TECHNICAL BULLETIN

[Issue No.] FA-A-0168

[Title] Changes in the rating plate of CC-Link

[Relevant Models] CC-Link, CC-Link/LT

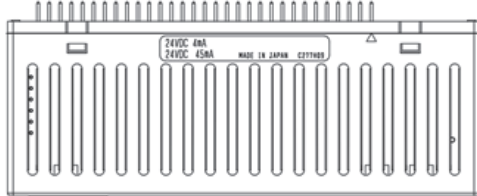
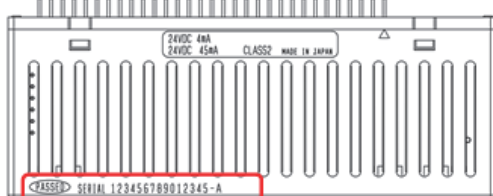
Item	Before change	After change*1
Separated into another plate	<p>Example: AJ65VBTC3-8D</p> 	 <div style="border: 1px solid black; padding: 5px; margin-top: 10px;"> <p>SERIAL 123456789012345-A See AJ65VBTC3-8D instruction manual. Voyez AJ65VBTC3-8D mode d'emploi.</p> </div>
	<p>Example: CL2X8-D1B2</p> 	 <div style="border: 1px solid black; padding: 5px; margin-top: 10px;"> <p>SERIAL 123456789012345-A See CL2X8-D1B2 instruction manual. Voyez CL2X8-D1B2 mode d'emploi.</p> <div style="float: right; text-align: center;">  <p>KCC-REI-MEK- TD915A827G51</p> </div> </div>
Moved to the module body	<p>Example: AJ65MBTL1N-32D</p>  	 <div style="border: 1px solid black; padding: 2px; margin-top: 5px; width: fit-content;"> <p><PASSED> SERIAL 123456789012345-A</p> </div>

*1: shows the added product number (SERIAL).
